Job	DUNSMORE ELEMENTARY SCHOOL	Scope	Construction of 2-Share Structures (PC # 02-113593), Alterations to 1-Building #2	
Change Order No.	Addendum No. 2	Deferred Submittal	Clarifications	Construction Change Document CCD : <input type="checkbox"/>
				Other <input type="checkbox"/>

ADDENDUM NO. 2

**DUNSMORE ELEMENTARY SCHOOL
KINDERGARTEN SHADE STRUCTURE
LA CRESCENTA, CA**

DSA Appl. No. 03-119278
STATE OF CALIFORNIA DSA File No. 19-41
DEPT. OF GENERAL SERVICES

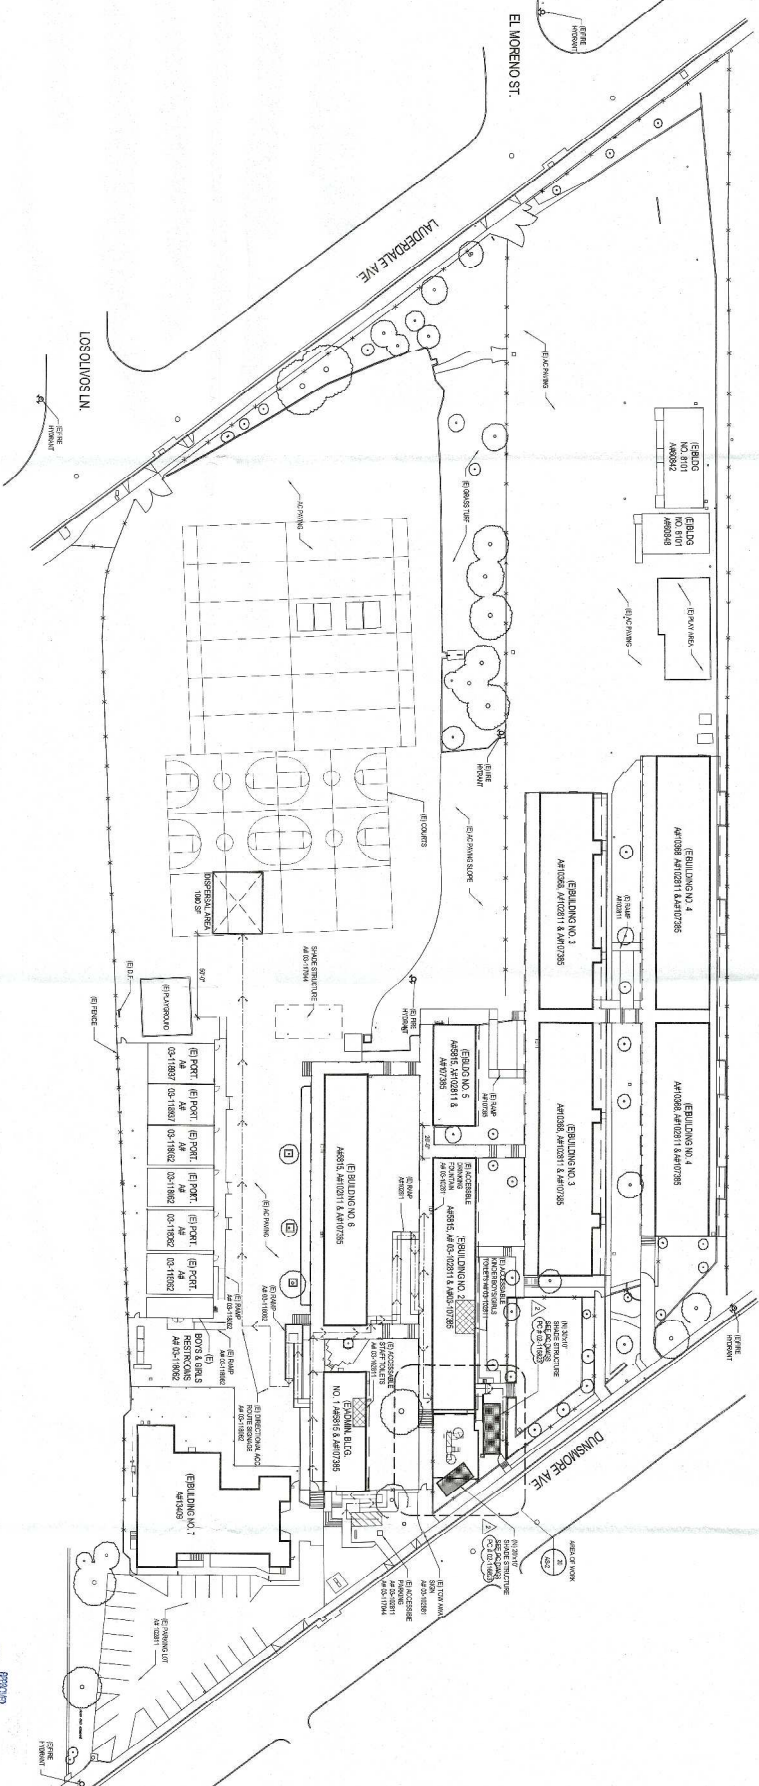
1. SHEET T-2 INDEX SHEET
Remove shade structure PC drawings 02-113593, and replace with PC drawings 02-116823.
2. SHEET AS-1 OVERALL CAMPUS SITE PLAN
Remove shade structure PC drawings 02-113593, and replace with PC drawings 02-116823.
3. SHEET AS-2 ENLARGED SITE PLAN & DETAILS
Remove shade structure PC drawings 02-113593, and replace with PC drawings 02-116823.
4. SHADE STRUCTURE PC DRAWINGS 02-116823
Replace 2013 PC Drawings with 2016 PC Drawings 02-116823.
